**Re: 444 East Central Street
MassDEP File No. Not Yet Issued
Notice of Intent Peer Review #2**

PEER REVIEW UPDATE – AUGUST 21, 2025

Figure 2: Floodplain exhibit depicting FEMA's mapping and longitude/latitude point referenced in ORAD.

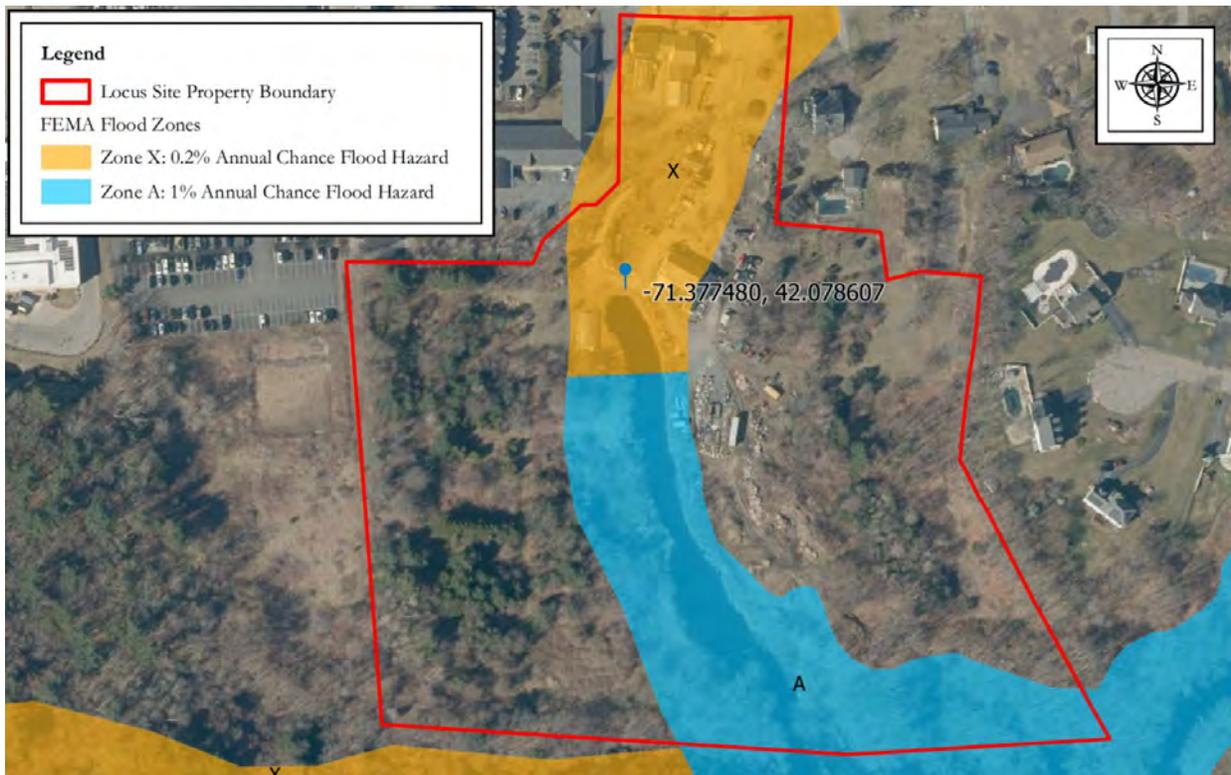
W24. The Applicant should provide further information regarding how the extent of BLSF at the Site was determined, as the ORAD only approved portions of the BLSF at the Site. Given the number of stream crossings / hydraulic restrictions present at the Site, this evaluation should be prepared by a Professional Engineer with experience in hydraulics. The Commission may require more up to date engineering information than what is provided by FEMA per (310 CMR 10.57(2)(a)3., particularly given the presence of a Zone A with no published base flood elevation.

As of July 8, 2025, FEMA has updated the map panel 25021C0309F to depict that a Zone A with no Base Flood Elevation (BFE) is present throughout the Site. Therefore, it is BETA's opinion that the change in floodplain mapping further supports the request for an analysis to accurately determine a BFE for the Site. It is BETA's understanding that the Applicant indicated to the Town via email on August 20, 2025 that this analysis would be performed in the coming weeks.

Figure 2 below illustrates two flood plains onsite, Zone X in the northerly area of the site and Zone A (100-year floodplain) in the south. Zone A constitutes BLSF, and its boundaries have

Although Comment W24 states that the Commission may require more up to date engineering information than is provided by FEMA per 310 CMR 10.57(2)(a)3, it omits the language stating that the Commission may only impose this requirement "in the event of a conflict". No information or data has been produced that conflicts with either the Applicant's delineation of the BLSF or the Applicant's assertion that BLSF does not exist north of the identified latitude/longitude point. In fact, all the information available indicates that no BLSF exists in the northerly area in question. FEMA defines this entire area as Zone X, and clearly Zone A cannot exist where a Zone X does. No Zone A is depicted by FEMA in this area. Information provided during the ANRAD process further supported the position that this area does not flood.

The Applicant has provided documentation and analysis supporting the delineation of BLSF as shown on project plans currently and as approved under the ORAD, which is consistent with FEMA's mapping and in compliance with WPA Regulations. No conflicting information has been produced, either in the ANRAD process or the NOI process.
